RHODE ISLAND DEPARTMENT OF TRANSPORTATION

I-195 Relocation – Contract 16 – Providence River Pedestrian Bridge

NOTICE TO PROSPECTIVE BIDDERS

ADDENDUM NO. 8 Prospective bidders and all concerned are hereby notified of the following changes in the Plans, Specifications, Proposal and Distribution of Quantities for this contract. These changes shall be incorporated in the Plans, Specifications, Proposal and Distribution of Quantities, and shall become an integral part of the Contract Documents.

SHEET: V2_064

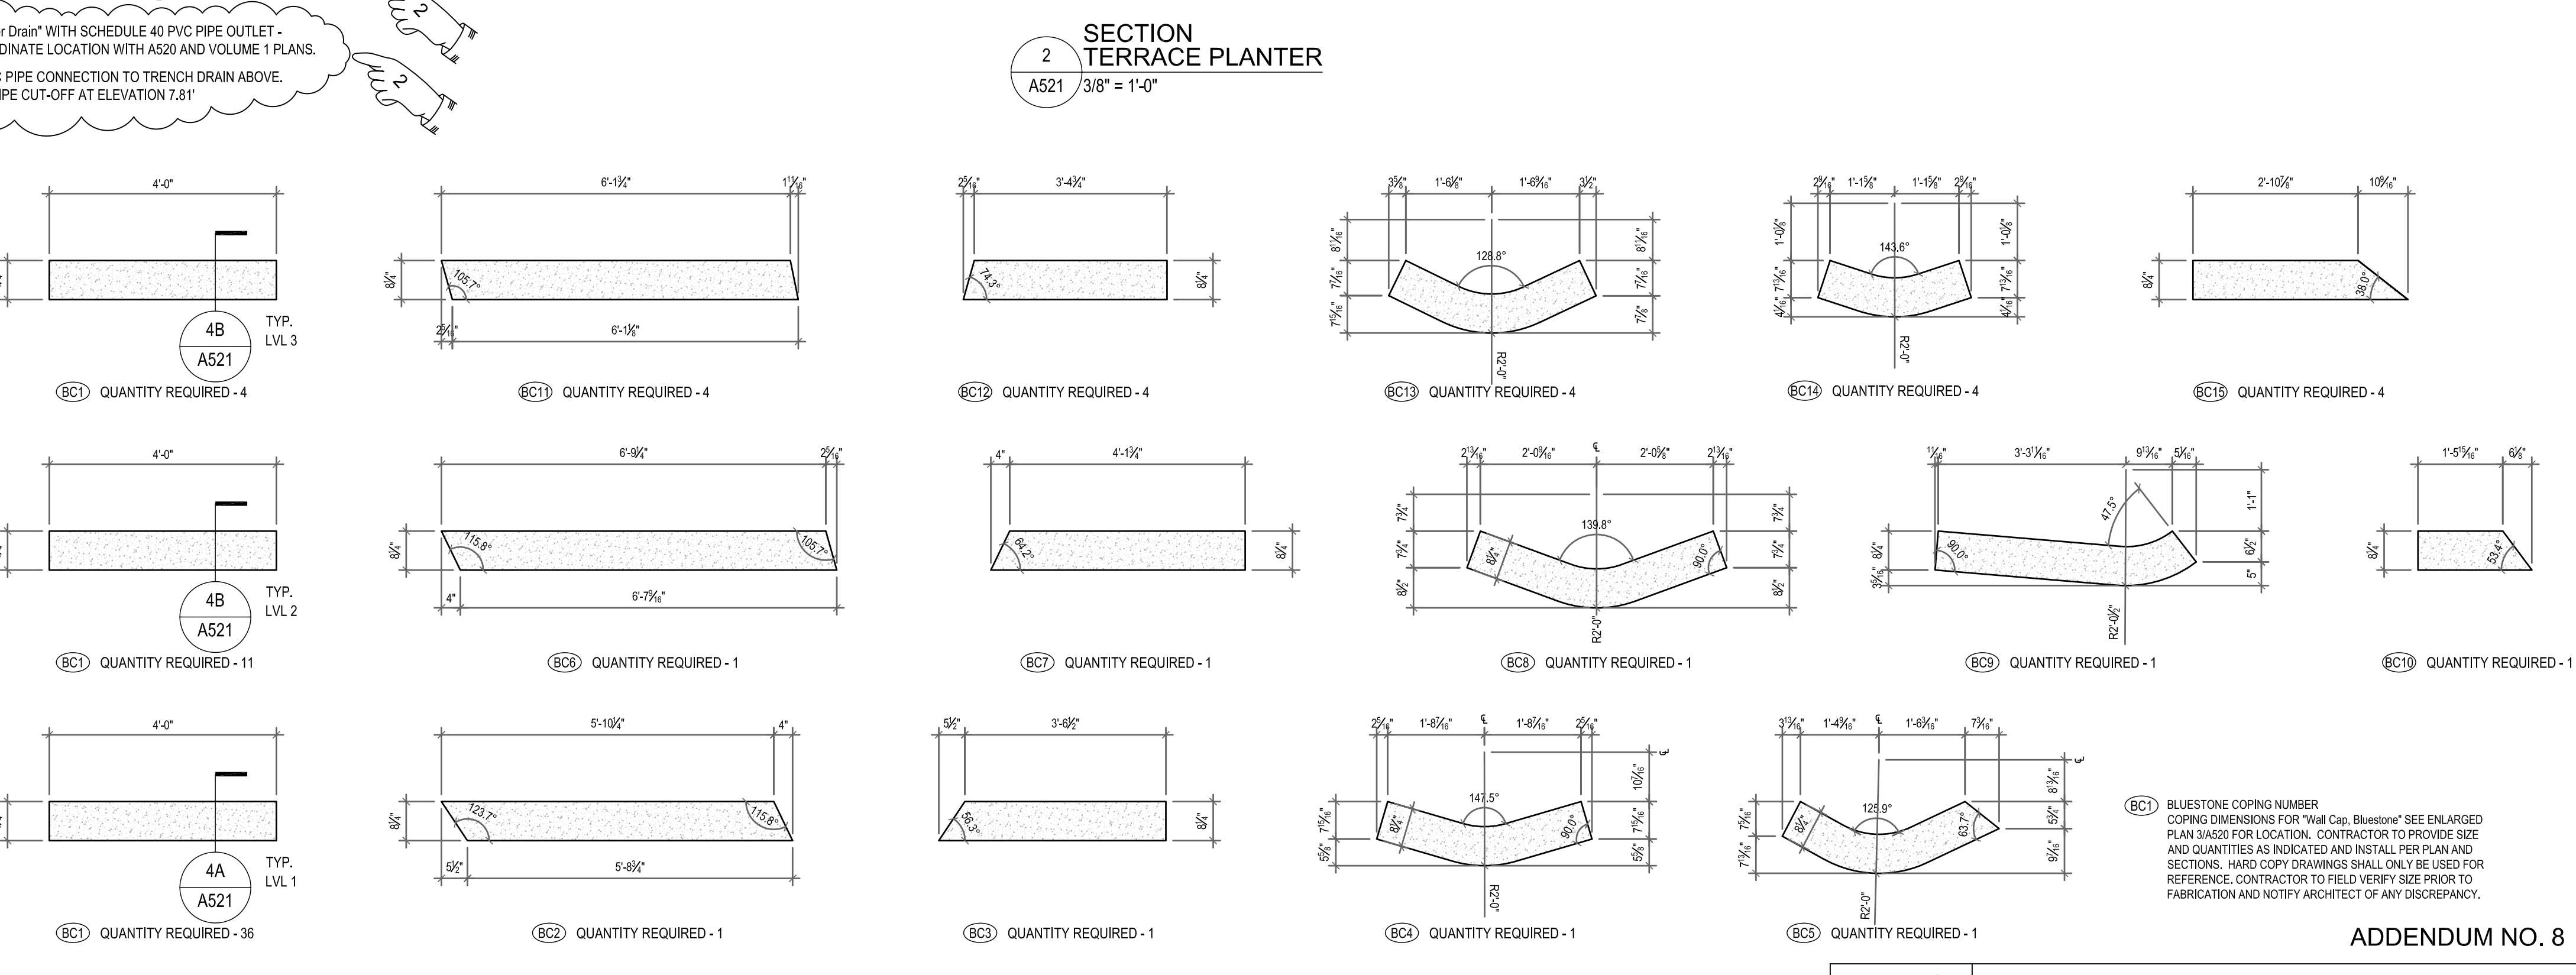
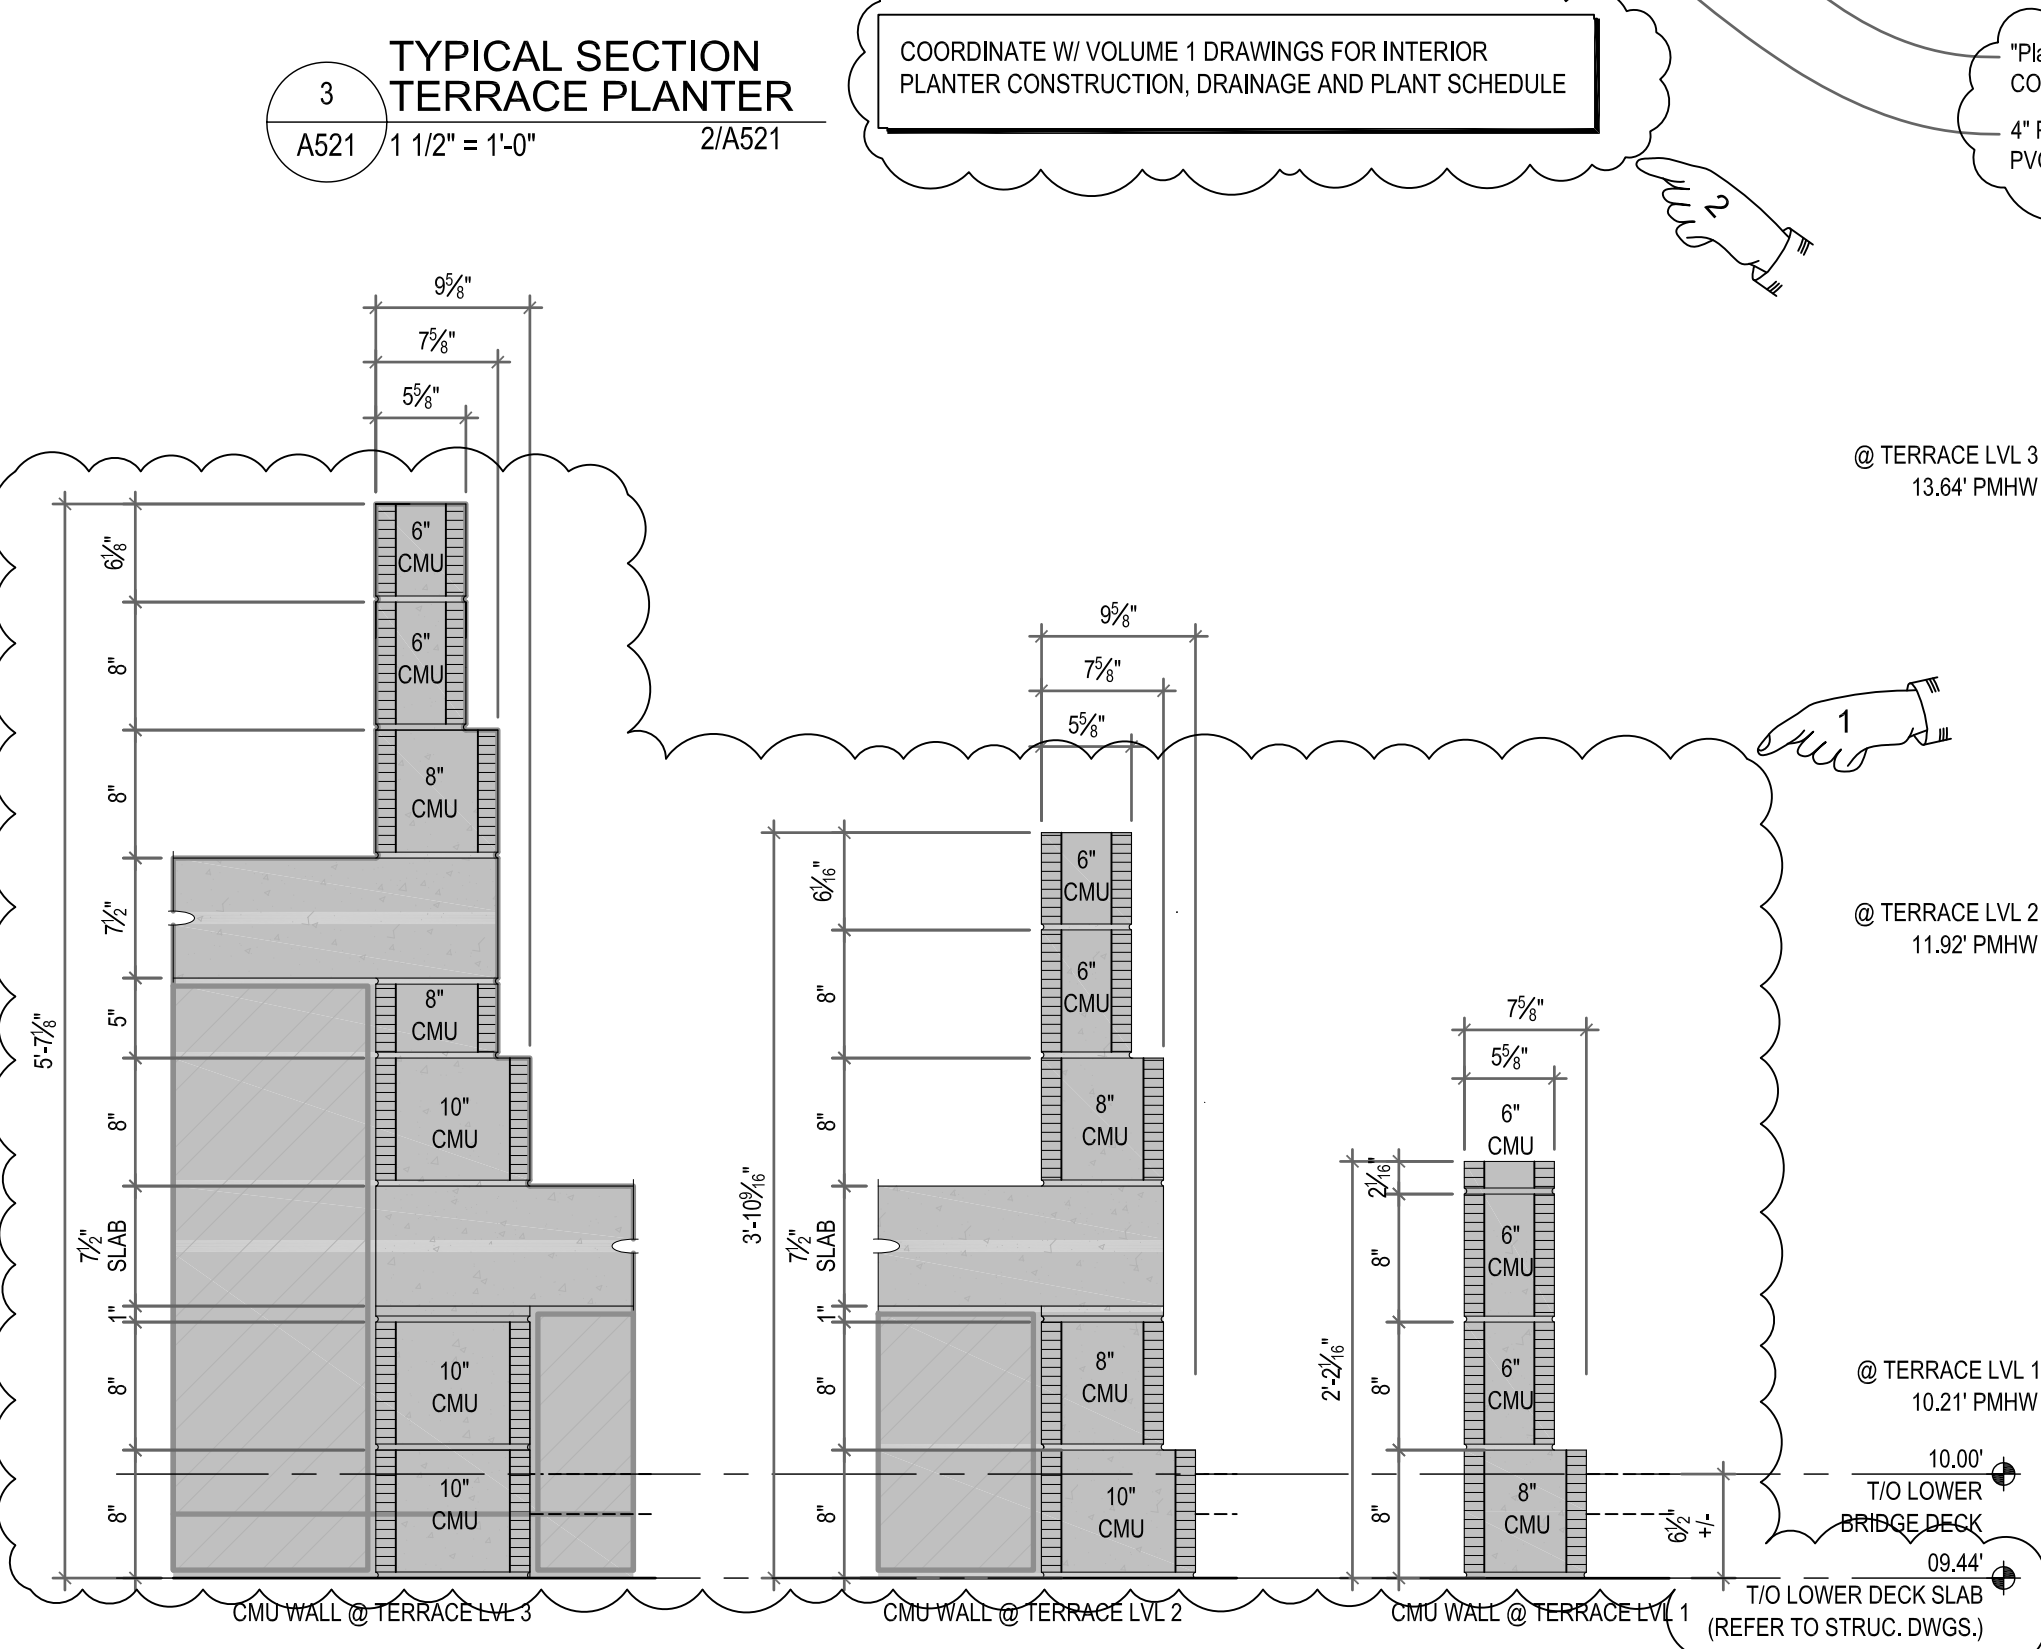
Delete Sheet V2_064(R-1) in its entirety and replace it with sheet V2_064(R-2) attached to this Addendum No. 8. Callouts for the railing details have been revised.
